CITY OF ALBUQUERQUE

**Re: TLC Pet and Uptown Cat Hospital
Grading and Drainage Plan
Engineer's Stamp Date 10-14-14 (J20D027)**

Based upon the information provided in your submittal received October 15, 2014, the above referenced plan is approved for Grading Permit but not Building Permit. Please address the following comments.

Grading / Drainage Plan

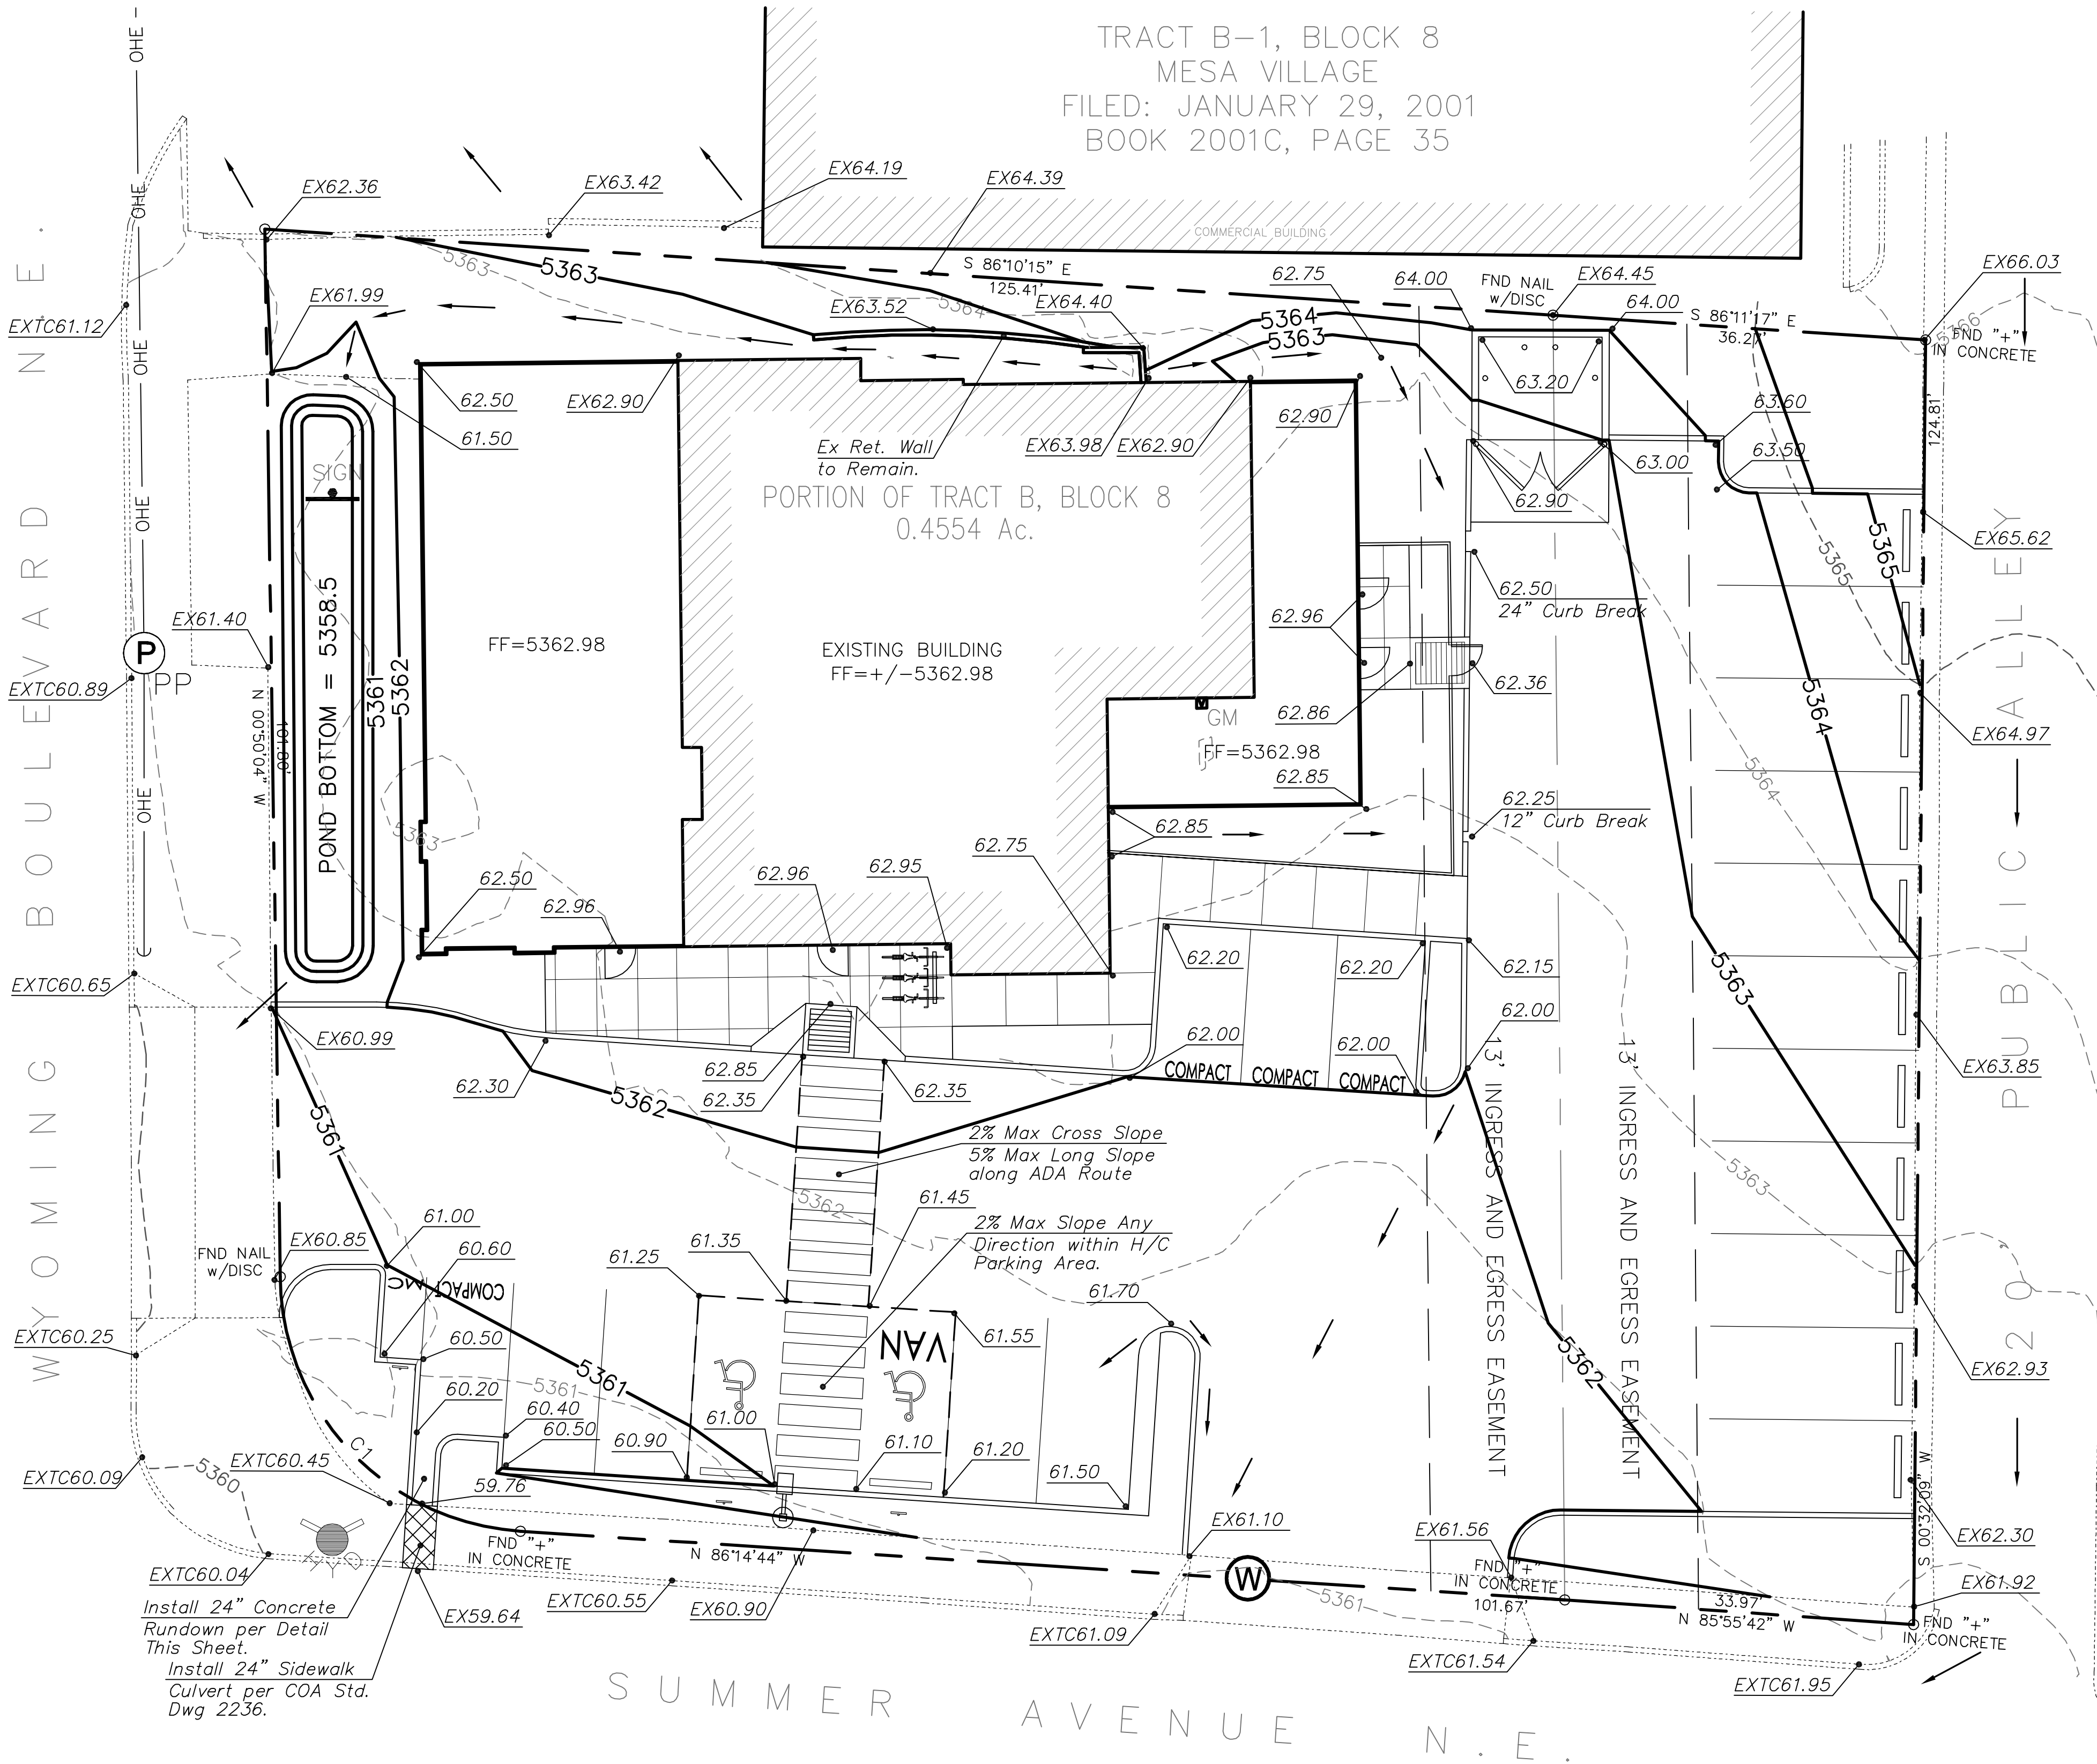
1. A S0-19 permit is required for this site because of the sidewalk culvert. The standard language is attached. Add this to the drawing. Also include a signature block for the City Inspector. Request S019 approval with the next submittal in addition to the Building Permit request.
2. The First Flush requirement is 0.34 inch multiplied by the impervious not 0.44 inch as shown on the plan. The 0.44 inch is reduced by 0.1 inch for the initial impervious abstraction in Table A-6 of Section 22 of the DPM. Not as much needs to be retained as stated on the plan.
